CERTIFICATE OF APPROPRIATENESS

RE: Application Number 21-7222; 1920 Atkinson, Atkinson Avenue Historic District

THE RECTORY

04 - 12 - 2021 HDC Set

2 North Elevation
A2.0 1/4" = 1'-0"

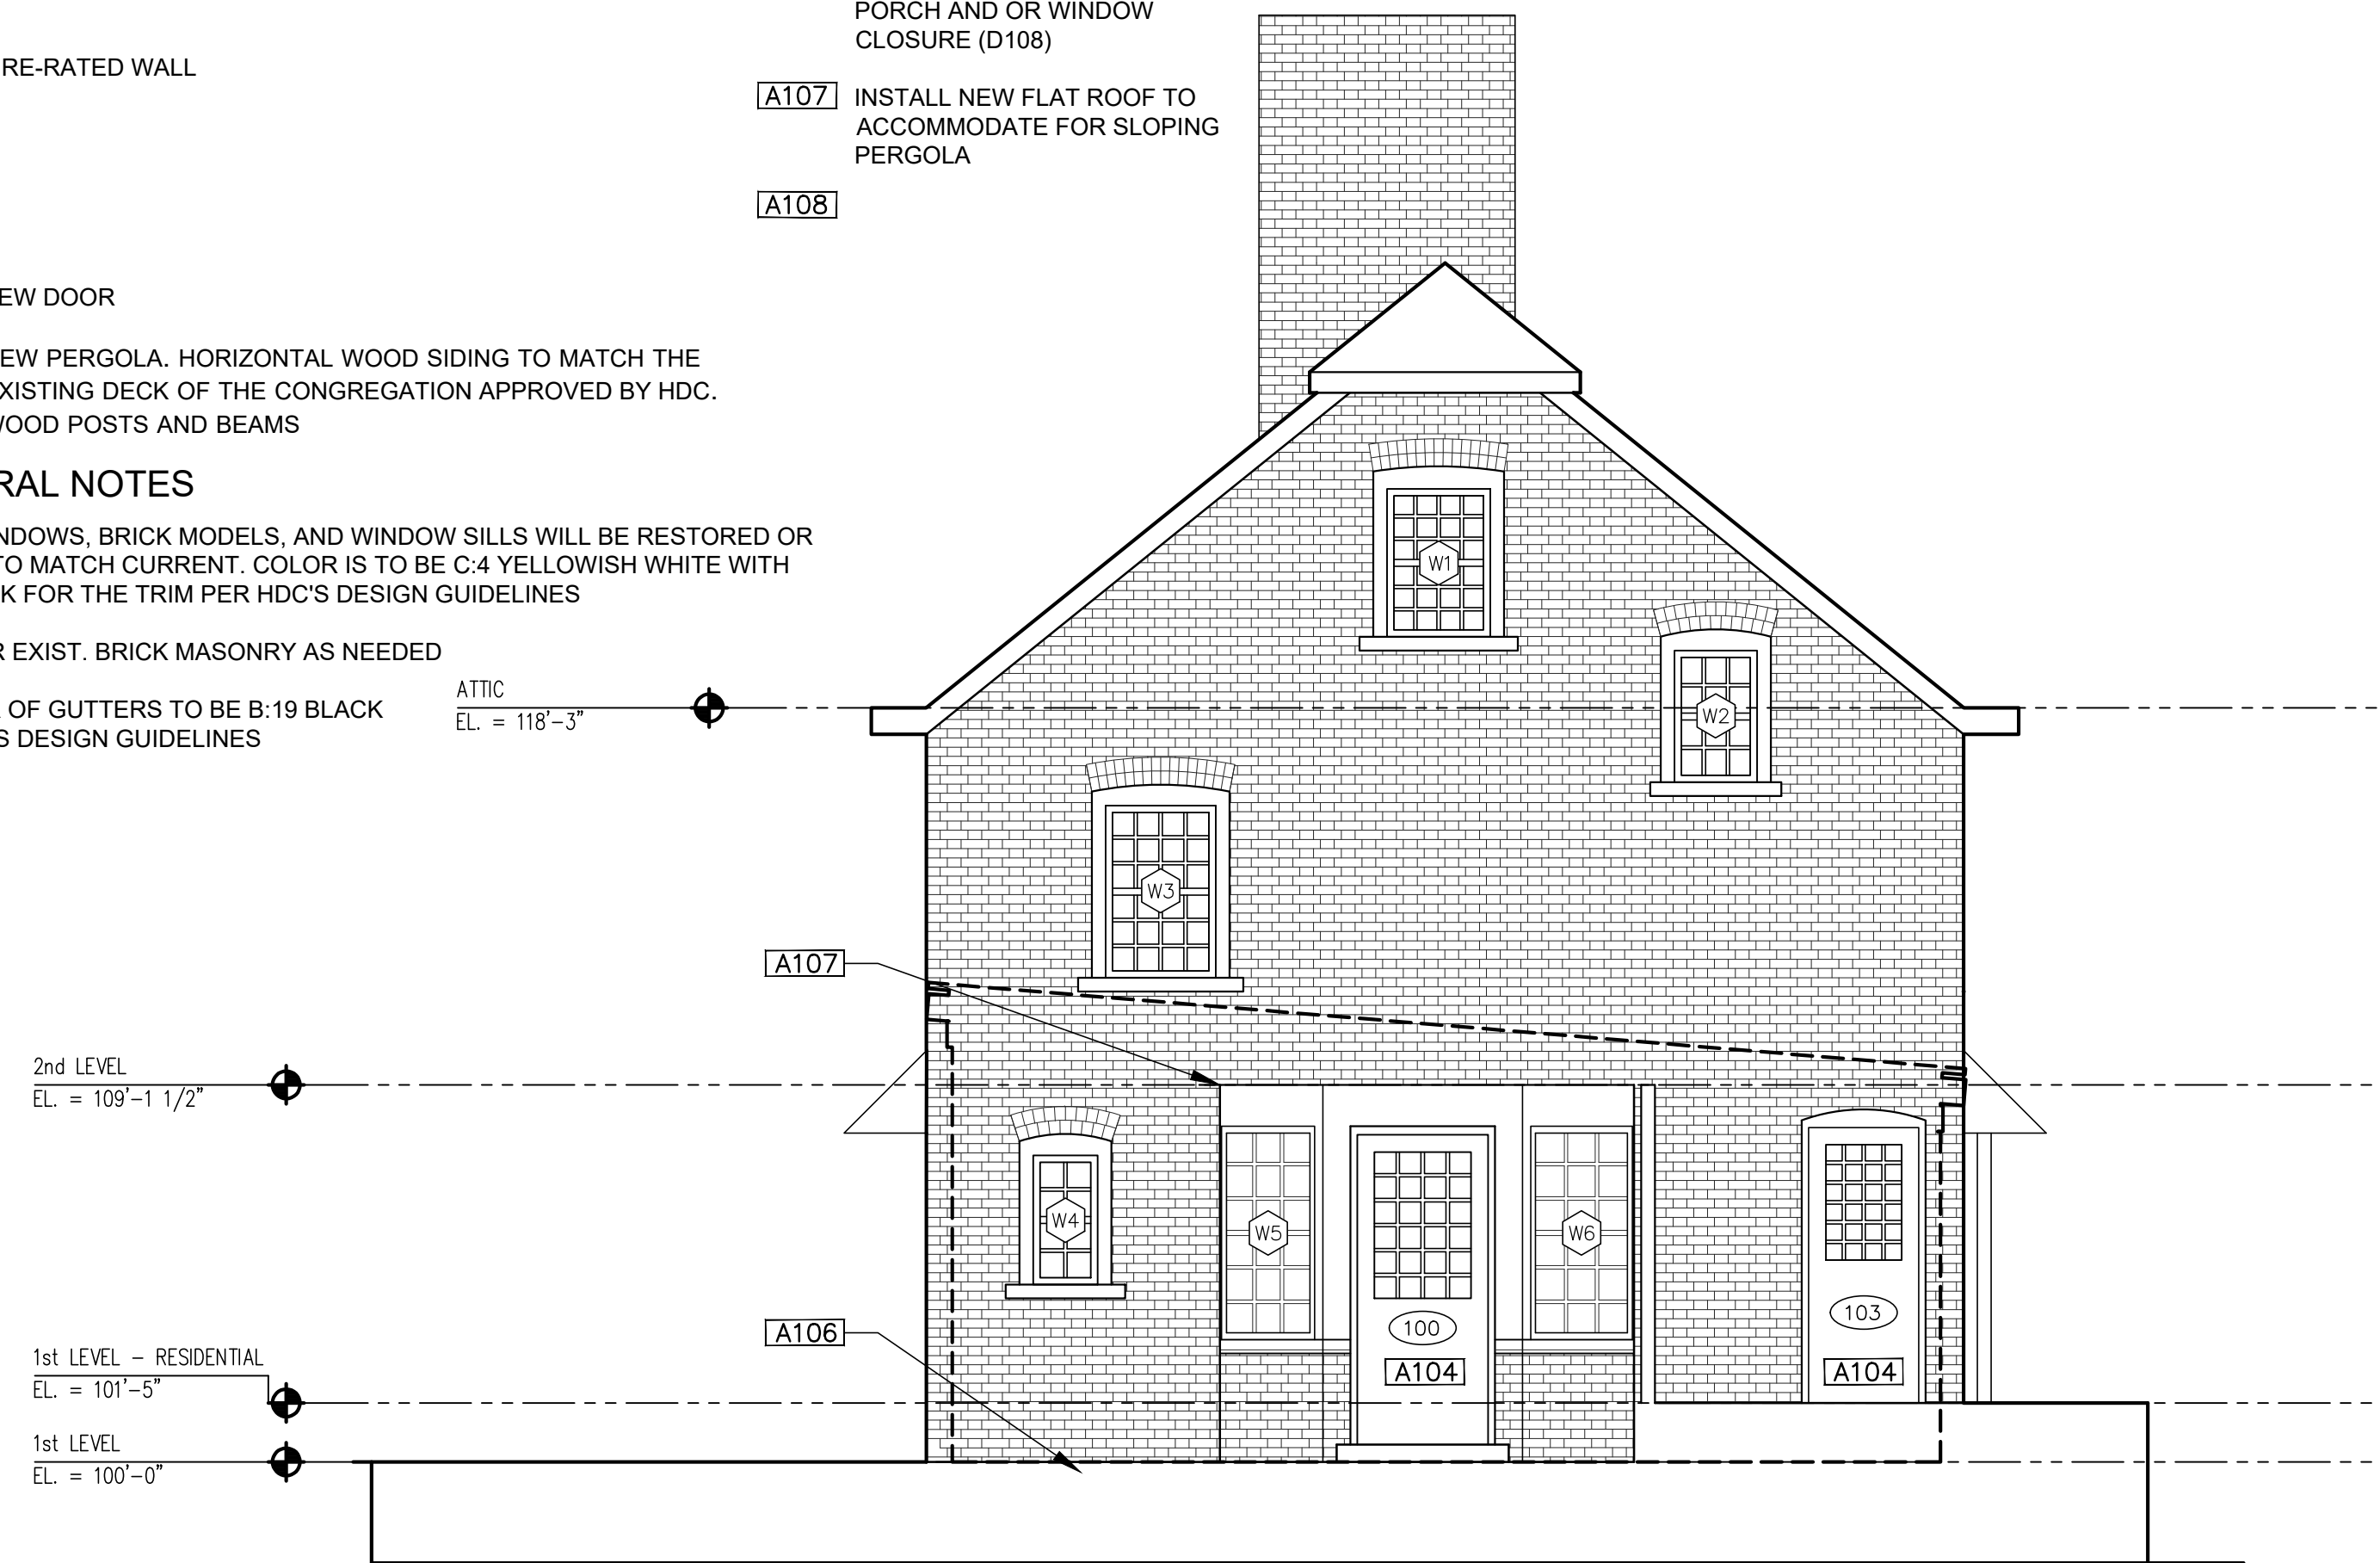
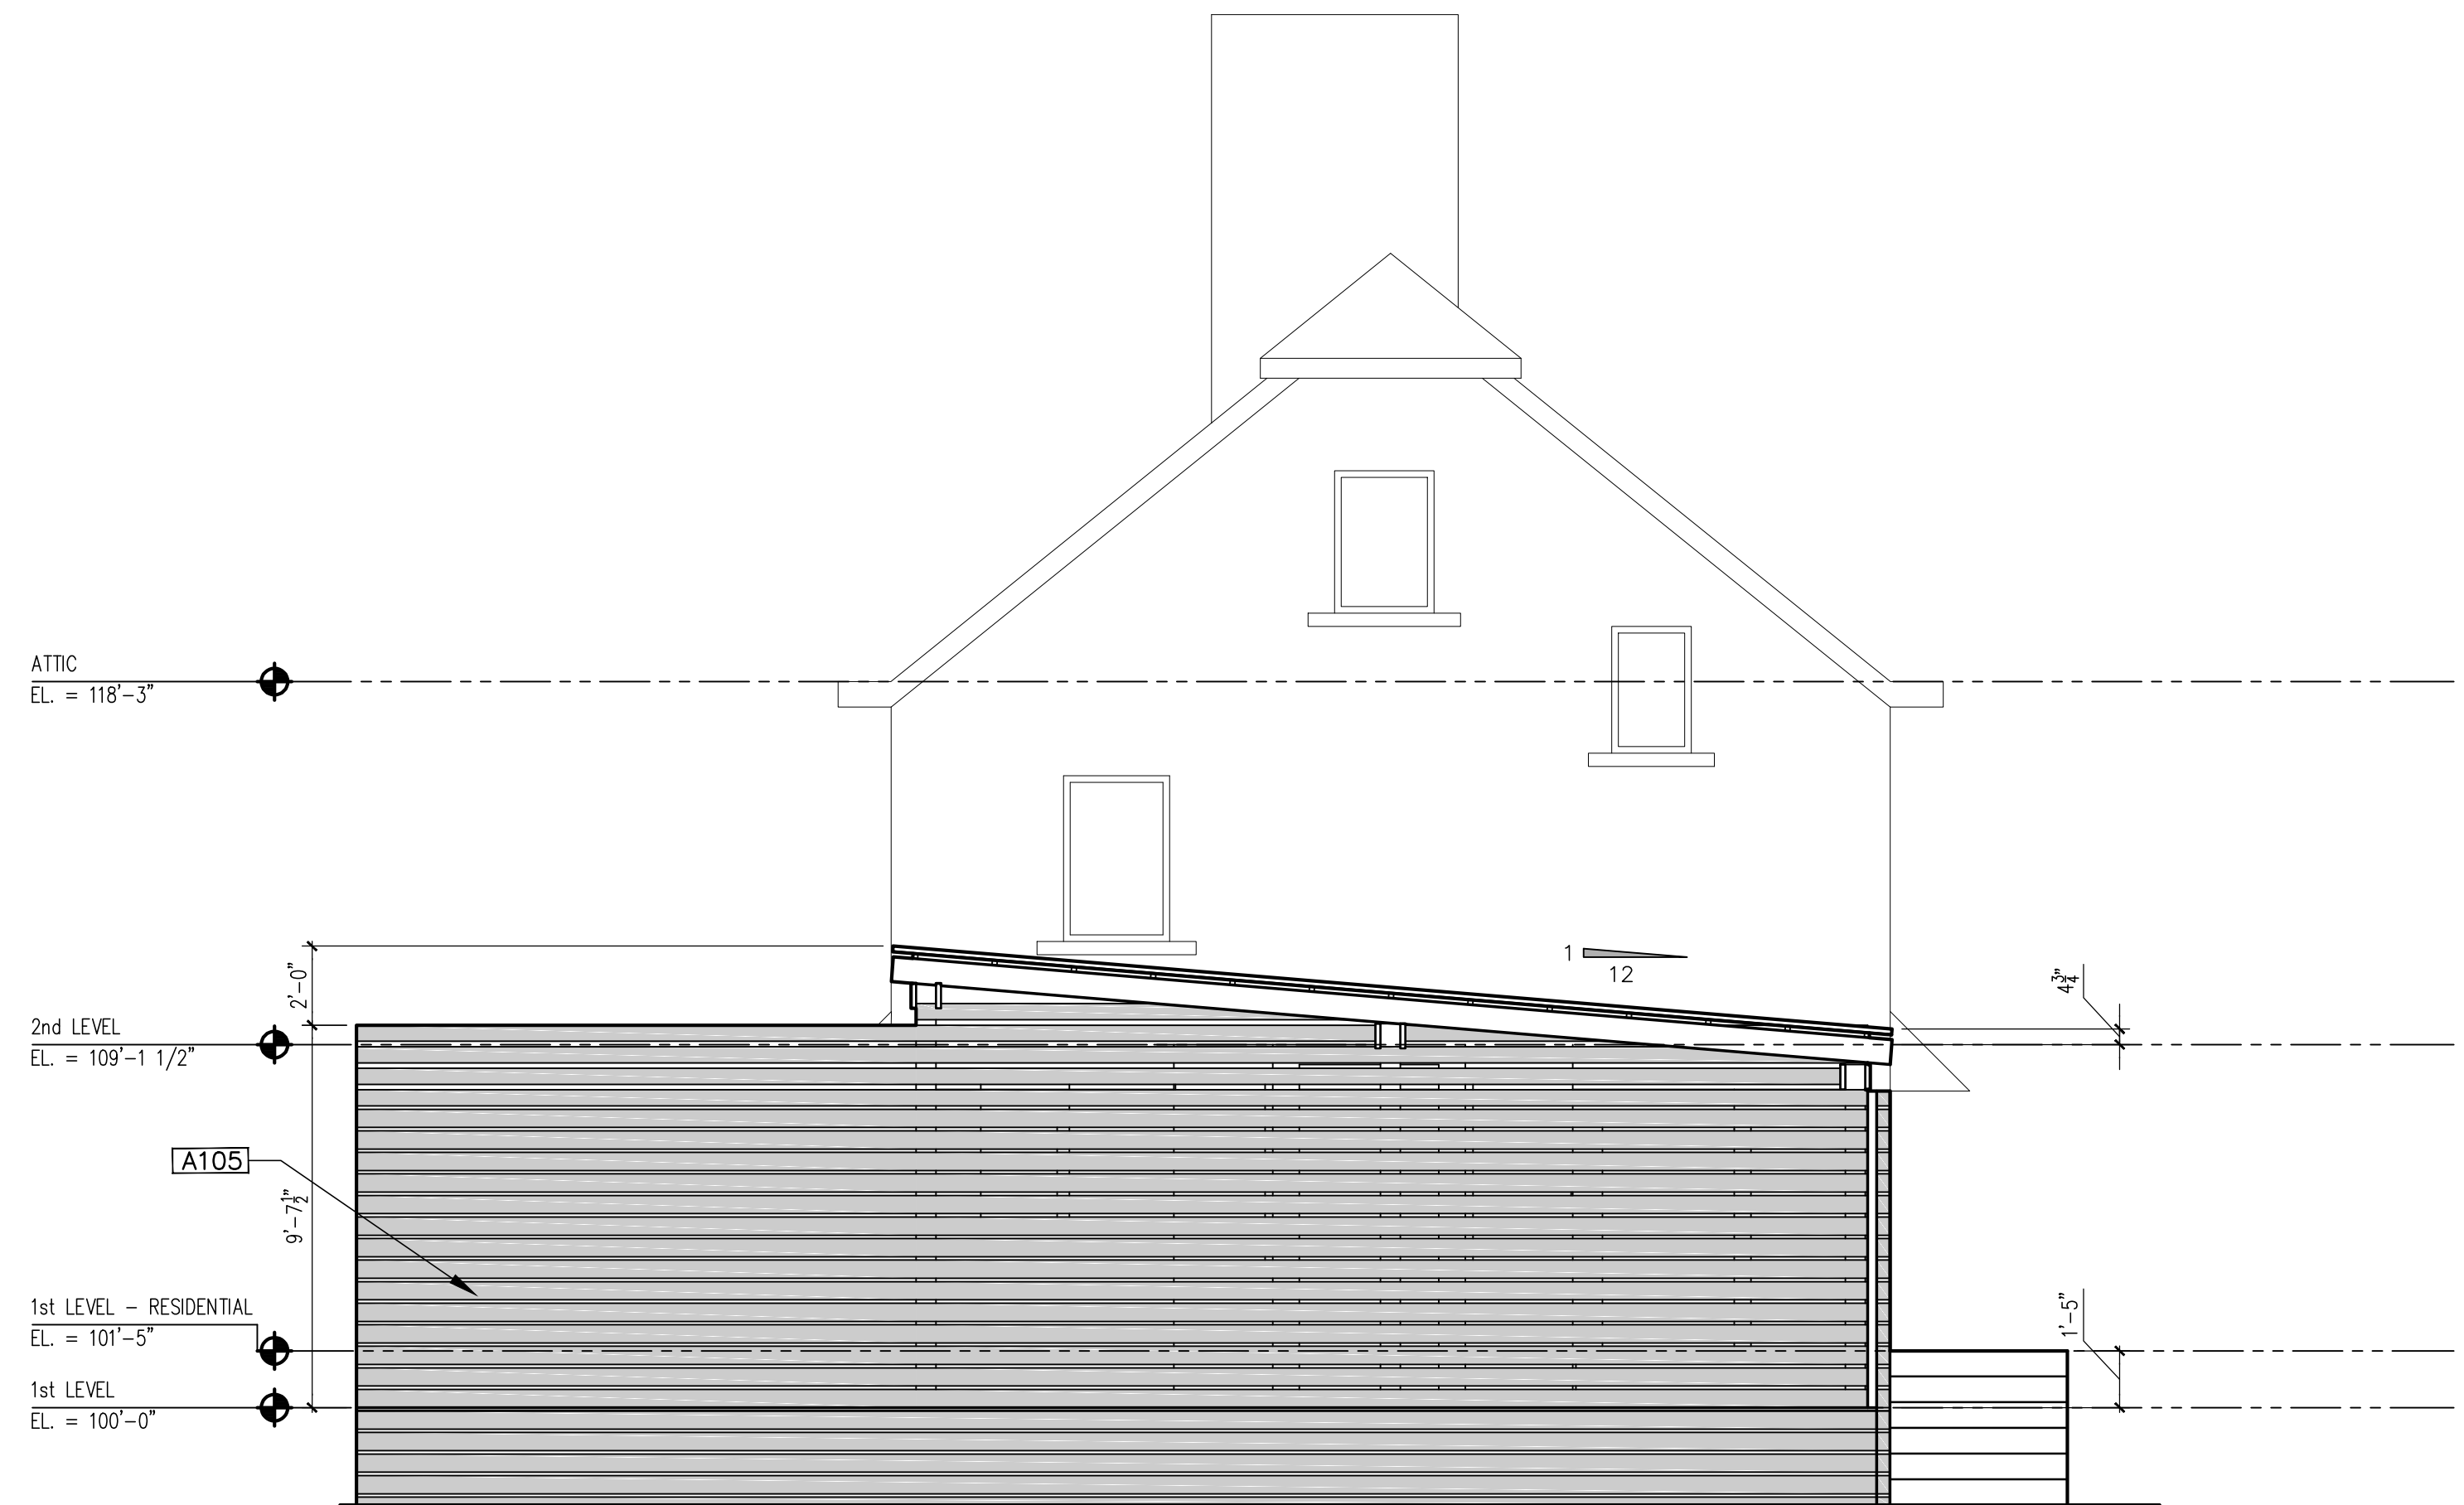
- 02: Elimination of an Existing Window (DW) for New Residential Door Entrance (103) at the back of the building.
 - New door sill height.
- 03: Move the Door (103) higher and further west to accommodate the new Residential Door Entrance (103) at the back of the building.

- A catalog cut for the rear entry railing will be submitted for staff review.
- Evidence of the window and door opening proposed for removal on the rear elevation will be retained and will consist of: the double rowlock headers and the brick infill will be laid in a running bond pattern within the openings. Vertical joints will be used to separate the infill brick from the existing brick wall.
